Planning Commission Meeting

Date: November 1, 2021

Subject: Site Plan Review – Lot 6 & 7, Meridian First Subdivision - Multi-tenant mixed use

• Request approval of site plan for a multi-tenant commercial building

COVER SHEET

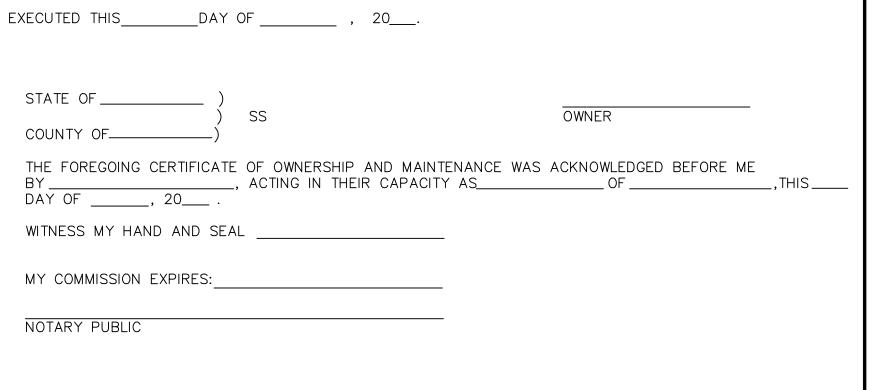
- The zone district label on the cover sheet needs to be updated on the revised drawings. There is no change on the plans and no text response from the applicant regarding this comment.

- The total building height is 34', 7.5." The cover sheet notes the height is 32'. The discrepancy should be verified and plans updated as necessary. The maximum building height for the C-3 zone district is 35'.

10. Landscape/Screening and Buffering: The cover sheet indicates that of the 72,786 square feet site, 14,600 square feet is for the landscaping and plaza (20%). The cover sheet states 12% open space requirement would equate to 8,734 square feet and that 18,911 square feet are provided.

- The courtyard is identified as being 14,600 square feet, 20% of the site area and meeting the open space requirement.
- Notes on the cover sheet for land area, open space and impervious surface area appear to be conflicting and should be verified for accuracy on the revised site plans. There is no change on the plans and no text response from the applicant regarding this comment.

- *Massing/scale*: The total building height is 34 feet 7.5 inches at the peak of the tower. **The cover sheet** states the height is 32', please confirm and edit as needed.

3-D Views

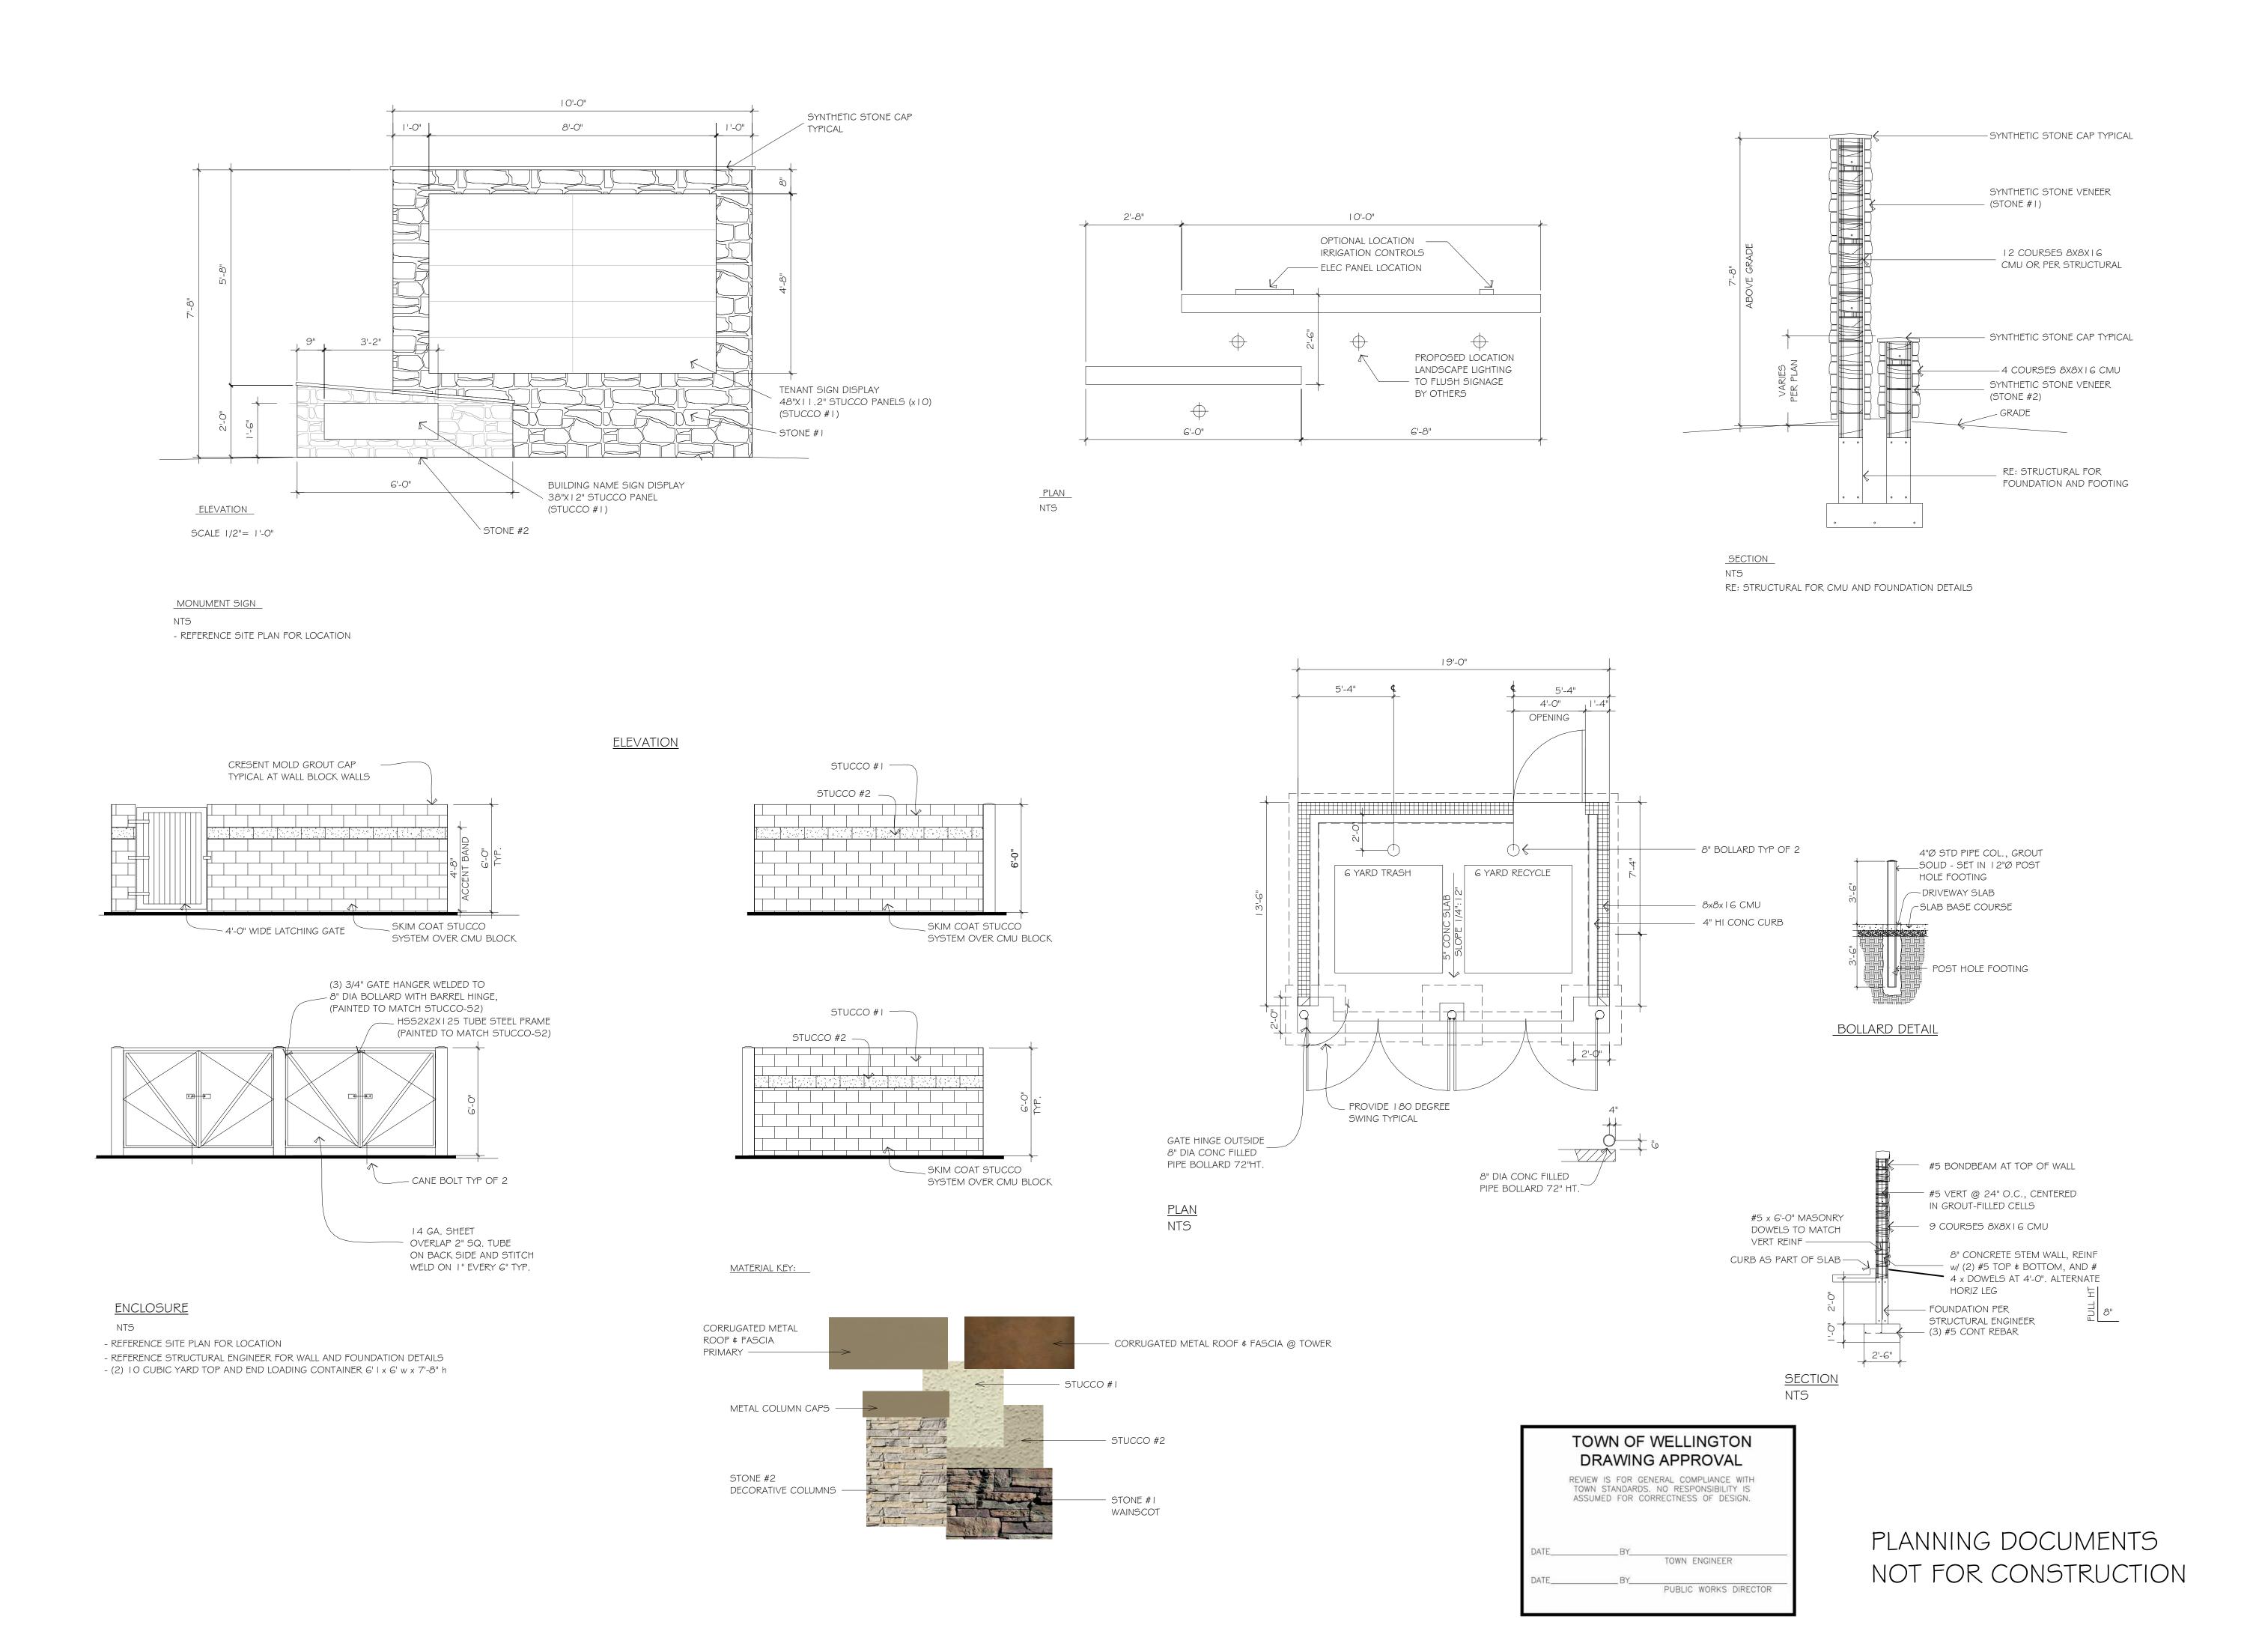
- Ensure wall light placement from the photometric plan is coordinated with the architectural drawings and commercial building plans. There are currently no lights identified on the architectural renderings. There is no change on the plans and no text response from the applicant regarding this comment.

- The color names for the proposed materials are not stated. There is no change on the plans and no text response from the applicant regarding this comment.

PROJECT NO: WBC DRAWN BY: 10/18/2021 DATE REVISIONS 10/18/2021 A-4.00

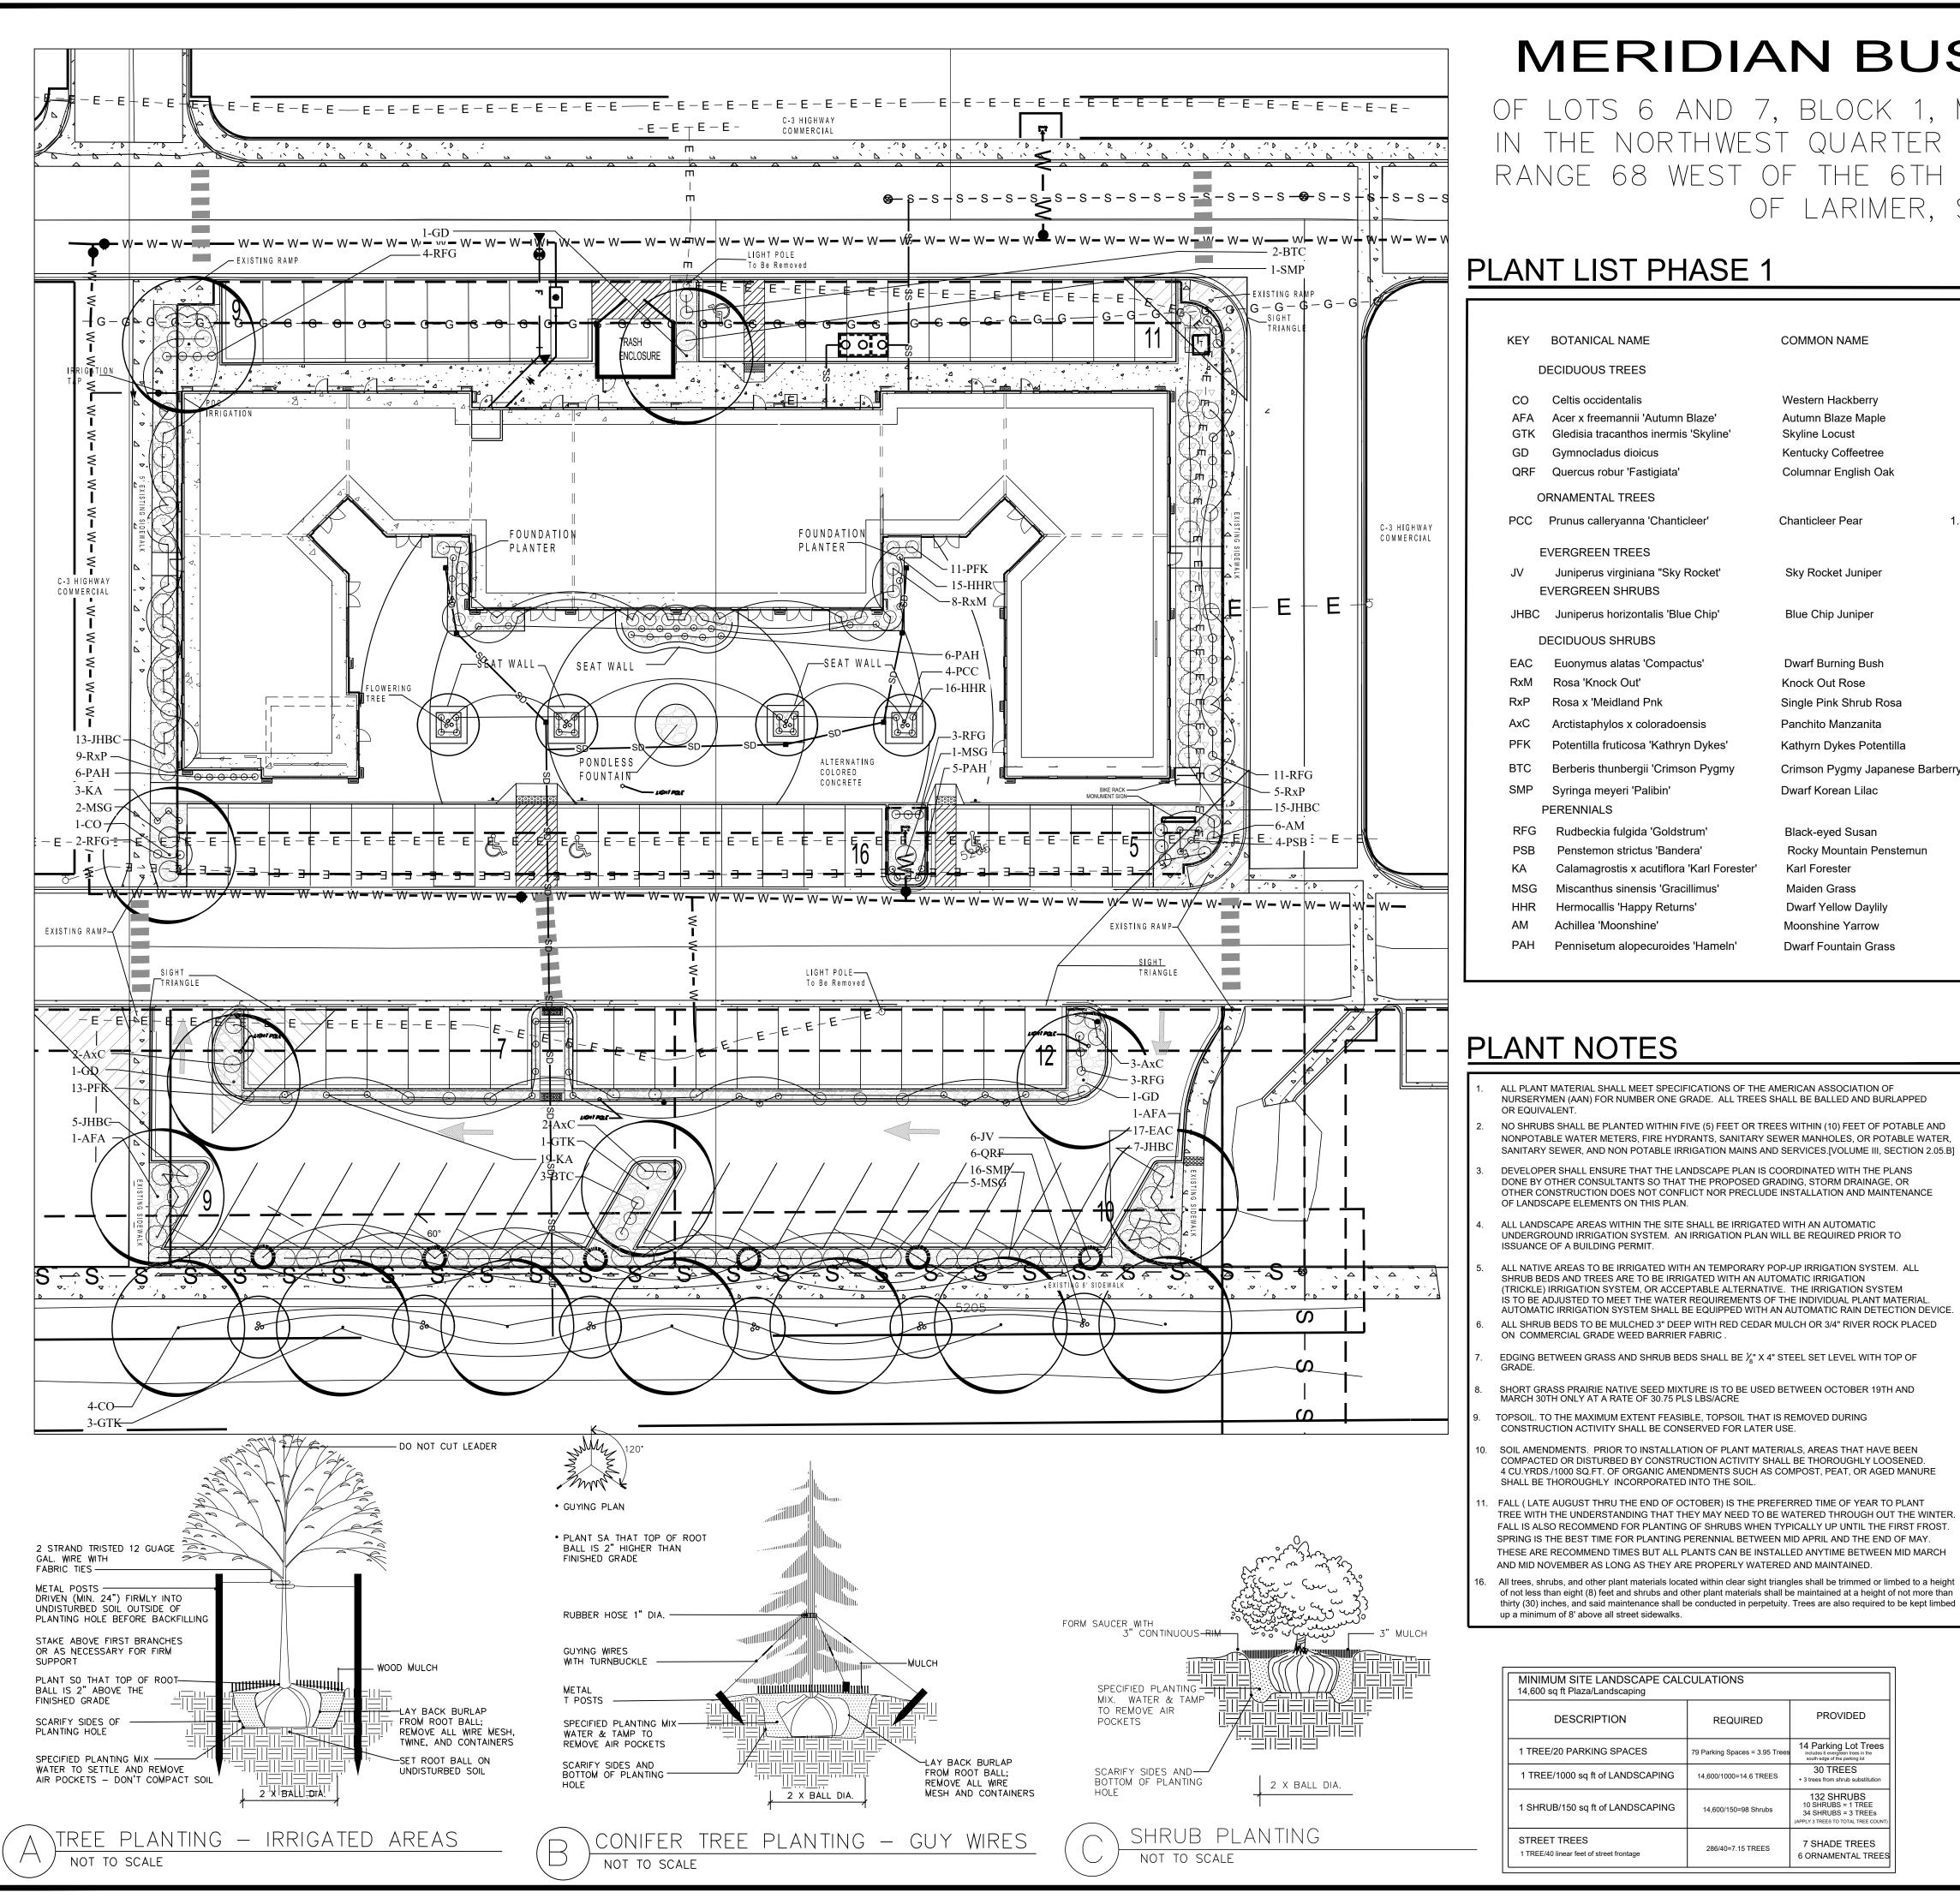
- The location does not interfere with the easement or site triangle.
- The monument sign allows for multi-tenant sign placement (each panel noted as 48"x11.2")
- The monument sign matches the building materials.
- The monument sign is 7' 8" tall and is 13'11" long.
- Staff requests the ability to administratively approve wall signs with tenant finish plans, provided the signs are within the applicable sign code regulations.
- 9. Site Lighting: A photometric plan was provided with the site plans as required. The Town's maximum illumination level at the property line is 0.1 footcandle.

- If material finishes on the building are modified, the dumpster enclosure materials should also be modified to match the building.
- Staff discussed with the applicant and design team a need to refer to Sec 16-3-420 which states location of the dumpster shall facilitate collection and minimize impacts. The applicant and team responded by moving the dumpster's location, which seems to be a more satisfactory location. Staff is still concerned with multiple trash pickups per week that there may be traffic congestion and trash maintenance problems for the tenants. This comment was considered at the Planning Commission on October 4, 2021. The Commission did not require any changes.

- 4. Identify the location, material, and size for a free standing sign that does not conflict with the site triangle or any easement.
 - Response: We identified the location of the monument sign on the drawings (please refer to sheet L1.0). We also added architectural details of the monument sign including material and size (please refer to sheet A-4.00).

- Response: Updated the trash enclosure to be consistent with the building architecture. Please refer to sheet A-4.00.
- 10. Add an employee access door for the trash enclosure.

- Response: Added an employee access door for the trash enclosure. Please refer to sheet A-4.00 and sheet L1.0.
- 11. Do not add a loading and unloading zone, which was a directive of the Planning Commissioners.
